# Accessibility Survey

## City of Downey Donovan Street & Lakewood Boulevard

Date of Inspection  
2/9/2017

Prepared By  
**Disability Access Consultants**  
(800) 743-7067

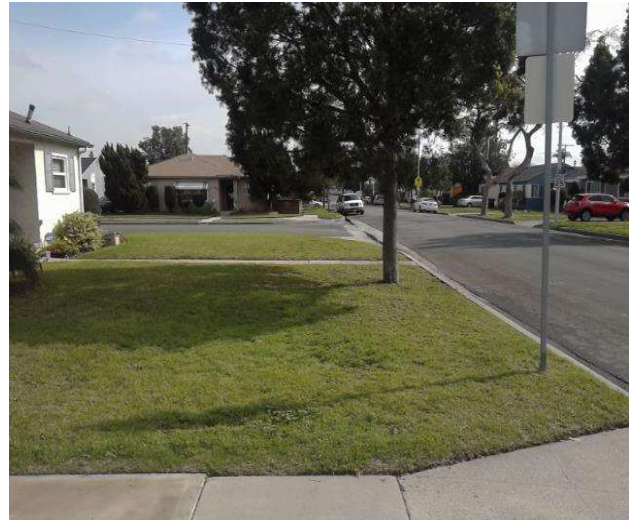
Section of sidewalk is missing and consists of dirt, grass or gravel.

**On-Site Finding** 65.00 feet

Provide a compliant sidewalk for the missing section.

**Change In Level West Of Brookshire Avenue @ 33.924261707717, - 118.142183572054**

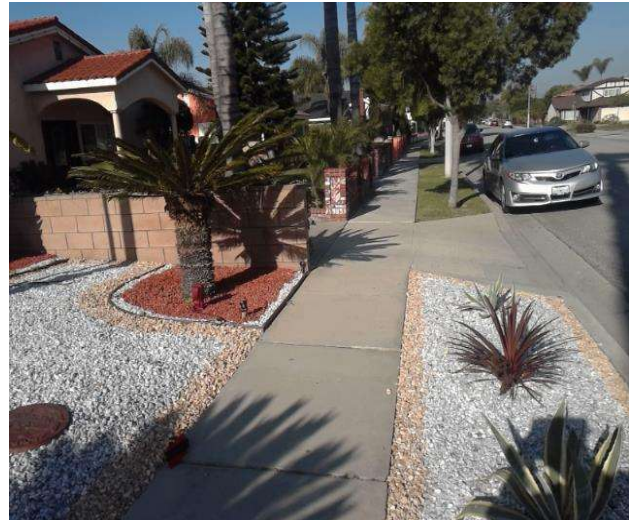
There is a change in elevation greater than recommended value.

**On-Site Finding** 0.75 inches

Ensure that the change in elevation is within the recommended value.

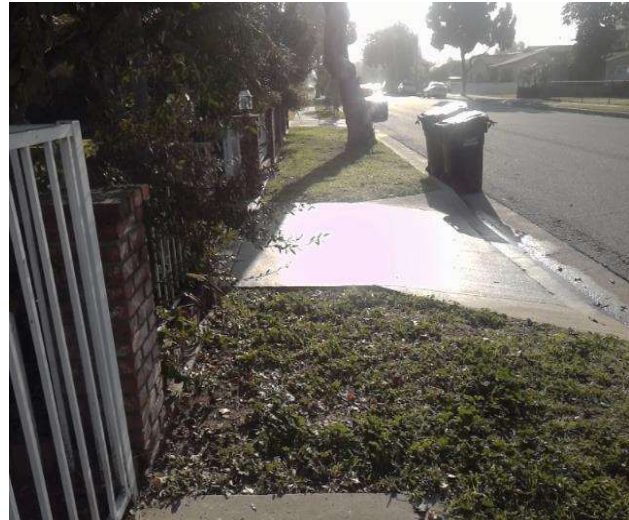
Section of sidewalk is missing and consists of dirt, grass or gravel.

**On-Site Finding** 54.00 feet

Provide a compliant sidewalk for the missing section.
